This administrative appeal of the Giant Sequoia National Monument Management Plan Final Environmental Impact Statement (FEIS) and Record of Decision (ROD), approved by Forest Supervisor Arthur L. Gaffrey on January 16, 2004, is filed on behalf of the Sierra Nevada Forest Protection Campaign, Sierra Club, The Wilderness Society, Friends of the River, and American Lands Alliance pursuant to 36 CFR 217.

Figure 1. Relationship between age and diameter for 439 trees 105 to 221 years old. Data taken from data set provided by the Sequoia National Forest on February 20, 2003.

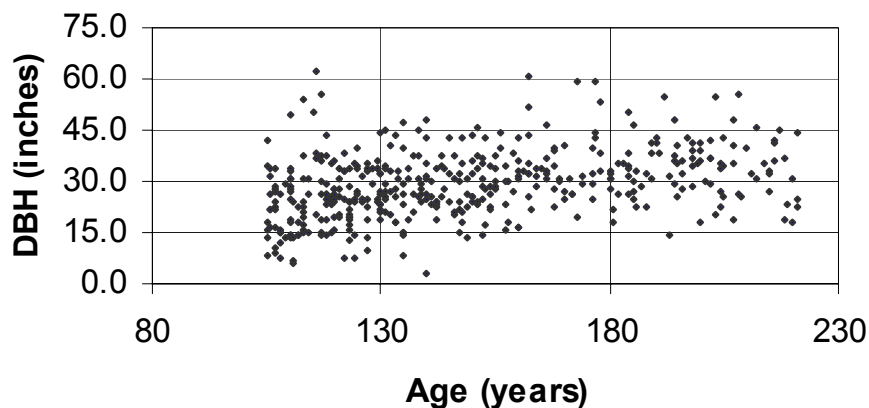
The FEIS displays a relationship between tree age and diameter which gives the impression that the age-diameter is a clean one with little variation in the data. In fact, the opposite is the case. We obtained the raw data used to create the age-diameter relationship in the FEIS and found that in reality there is tremendous variability inherent to this relationship. This variability is illustrated in Figure 1 below. The variability shows that there are a significant number of trees that are less than 30 inches in diameter and older than 130 years. For example, in this sample of 439 trees approximately 28 percent of the trees are smaller than 30 inches in diameter and older than 130 years. Under Modified Alternative 6, these are the very trees that would be targeted for removal.

Even when the diameter limit is set at 20 inches, trees older than 130 years could be removed. In this data set, about 6 percent of the trees 20 inches in diameter and less are more than 130 years old.
